**Freightliner  
 Service Bulletin**

# 09-34

## EPA10 Cummins ISX Air Intake Heat Shield Removal

**Fig. 1, Heat Shield Removal, No-Bracket Design**

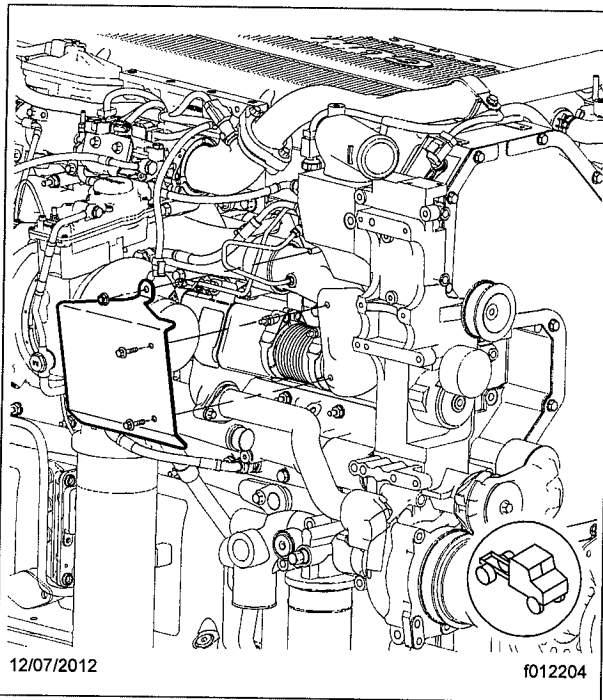
Cummins ISX engines in EPA10 Cascadia and Coronado models have one of two heat shields installed to protect the air intake ducting from possible high temperatures. Further testing has determined that this heat shield is not needed. If damaged, the heat shield should be fully removed, and not replaced. If the heat shield is not damaged, no action is necessary.

Both heat shield designs have three mounting points. See Fig. 1 and Fig. 2. The heat shield installation that includes a lower bracket should also have the bracket removed, so it cannot vibrate and cause stress at the mounting points. Access to the lower-rearward nut on this bracket may be difficult due to the EGR pipe. To loosen the nut, use a 13 mm 1/4-inch-drive U-joint swivel socket; see Fig. 3. Depending on the brand of socket, it may be necessary to trim the length of the socket slightly to gain enough clearance to remove the nut.
